## Clinton Power Station

Clinton Power Station, Unit 1  
Facility Operating License No. NPF-62  
NRC Docket No. 50-461

Subject: Request for Amendment to Technical Specifications to Permit Inclined Fuel Transfer System Blind Flange Removal During Power Operations

**Figure 1**

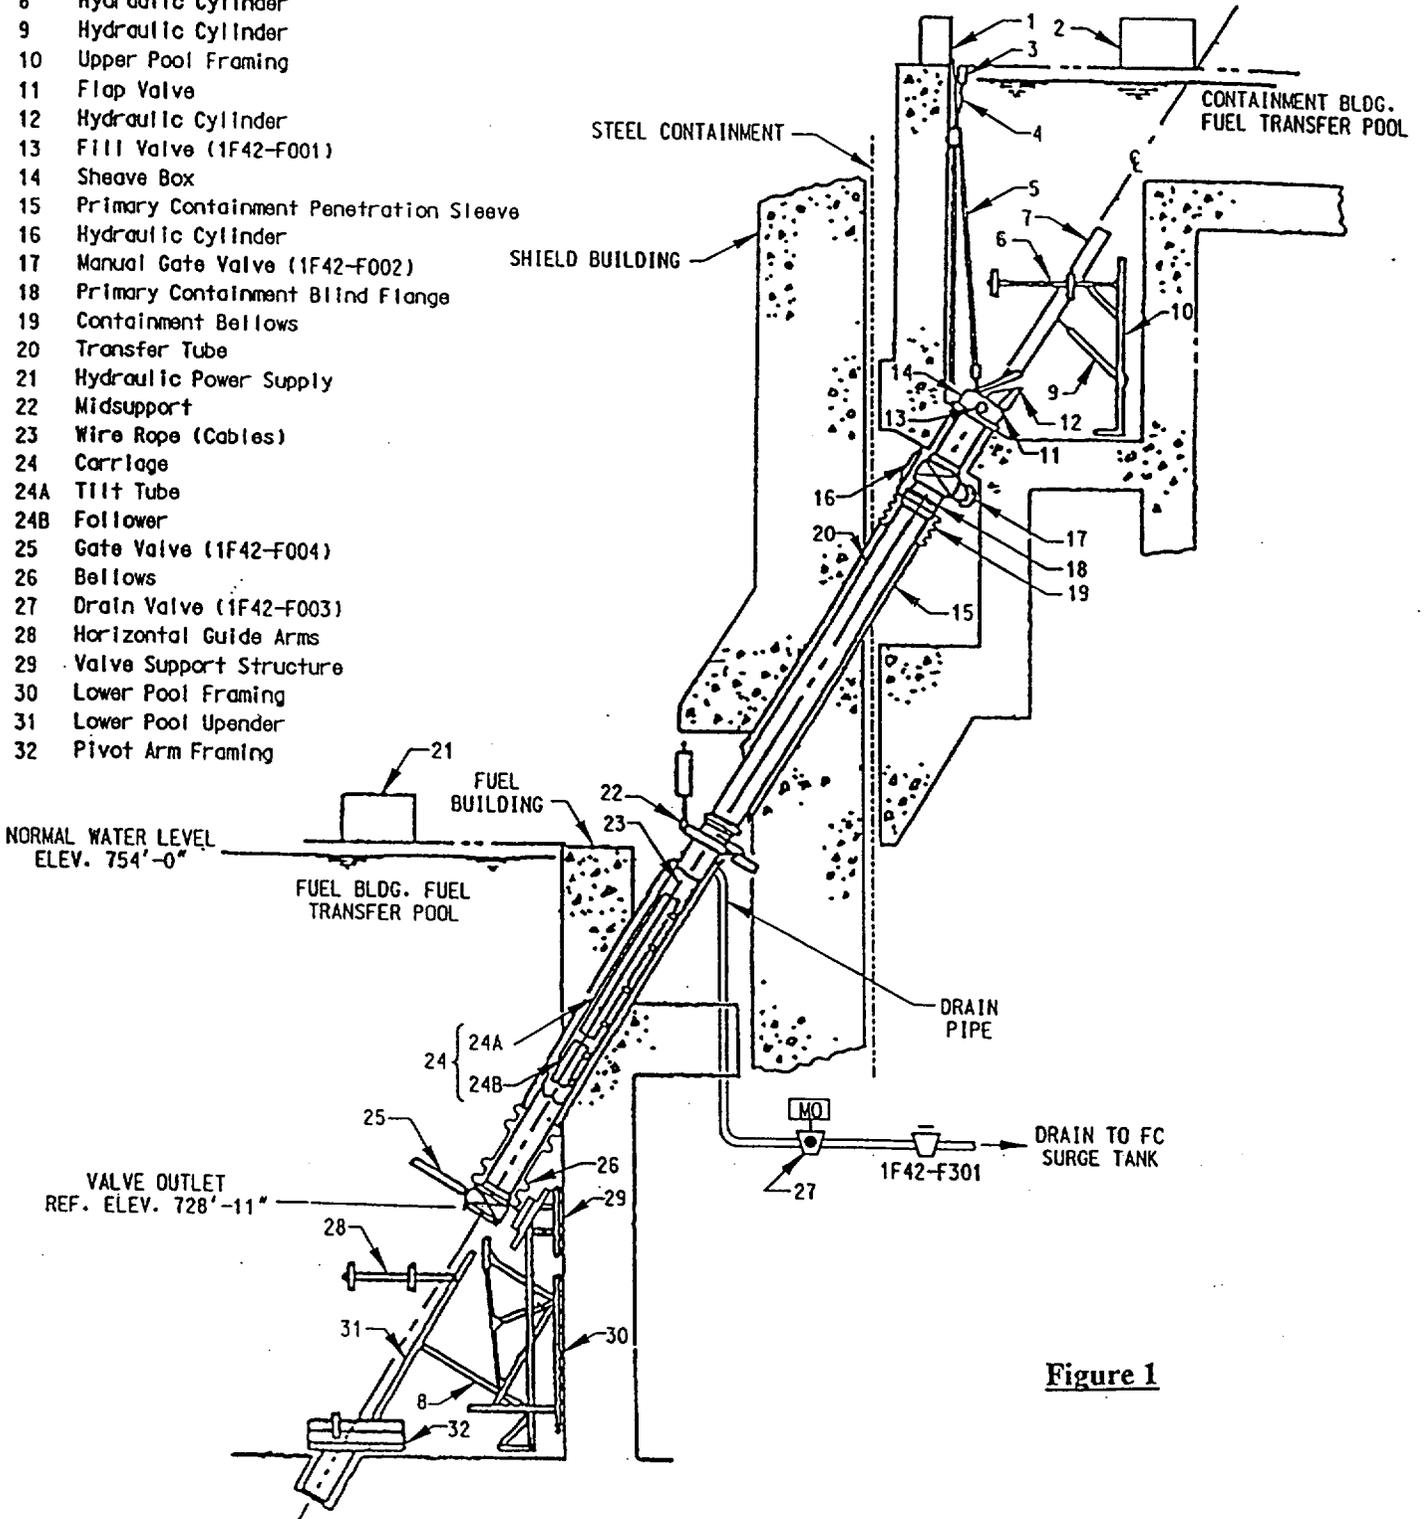
The IFTS at CPS (Figure 1) is used to transfer fuel assemblies, control rods, defective fuel storage containers, and other small items between the pool in upper primary containment and the lower-elevation pool in the adjacent fuel building (i.e., secondary containment) by means of a carriage traveling in an inclined transfer tube. The IFTS is a fixed installation, consisting of the inclined fuel transfer tube, upper and lower upenders, hydraulic power units, an electrically powered winch, carriage, and instrumentation required for the control system that includes redundant inputs for status indicators, and both a manual and semi-automatic programmable computer control facility.

The transfer tube (Figure 1, Item 20) is a 23-inch internal diameter stainless steel pipe, and provides a sealable, enclosed path for the carriage which is lowered and raised by means of a winch assembly. In the primary containment pool (i.e., upper pool), the transfer tube connects to the pool penetration and to a sheave box. The position of the carriage in the tube is tracked by a calibrated position system. The transfer tube is suspended between two flexible seals, or bellows. The transfer tube includes a valve at both ends, and is provided with a primary containment isolation assembly. The valve at the upper end, known as the flap valve (Figure 1, item 11), consists of a 24-inch disc with an actuating cylinder (Figure 1, item 12) and is mounted on the sheave box (Figure

1, item 14). The lower end has a 24-inch hydraulically operated gate valve (Figure 1, item 25).

The primary containment isolation assembly consists of two pipe spools separated by a removable blind flange (Figure 1, item 18) that is connected to the primary containment penetration via a flexible metal bellows (Figure 1, item 19). The blind flange normally forms a part of the primary containment boundary. Before the IFTS can be placed in operation, the containment isolation assembly must be disassembled and the flange replaced with a gasketed ring, and reassembled. The spring hanger and snubbers (Figure 1, item 22) at the mid-section of the transfer tube provide support and seismic restraint for the system. At the connection of the two transfer tube sections, the 4-inch drain line and the "tube-drained" liquid level sensors are installed.

1. The manual gate valve (Figure 1, item 17) is closed.
2. Bolts are removed from the containment isolation assembly as required to allow insertion of the blind flange (Figure 1, item 18).
3. The transfer tube (Figure 1, item 20) is lowered with the hydraulic cylinders (Figure 1, item 16).
4. The blind flange is inserted and bolts are installed.
5. The transfer tube is pulled up with the cylinders (Figure 1, item 16).
6. The bolts are tightened and the pressure on the cylinders (Figure 1, item 16) is relieved.

With respect to the IFTS and its associated containment penetration, containment operability is made by the blind flange (Figure 1, item 18), containment bellows (Figure 1, item 19), and the steel containment penetration. Special gaskets are provided for leak checking to assure containment isolation. Installation of the blind flange is the normal
